City of South Pasadena Planning and Community Development Department

Memo

Re: Additional Document No. 1: Public Comments on Item #2

Mike Fazioli commenting/inquiring on Agenda Item #2 SPMC regarding ADU:

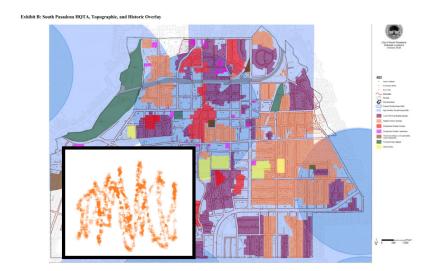
This is a map taken from South Pasadenas RHNA appeal.

The bottom left is the high risk fire zone. I drew a fire on it for labelling. There are special rules for this area including sprinklers, which have to be within 150 feet of the front property line, and replacement parking.

The colored areas represent historic districts where there are more restrictions and design standards/guidelines. Most of the places that are not colored are the multi family homes in South Pasadena. So this ordinance will apply to almost no single family homes in South Pasadena while making it harder to build ADUs in all of South Pasadena. I believe you should look more closely and see what parts of South Pasadena are truly historic and should have the stricter design standards applied.
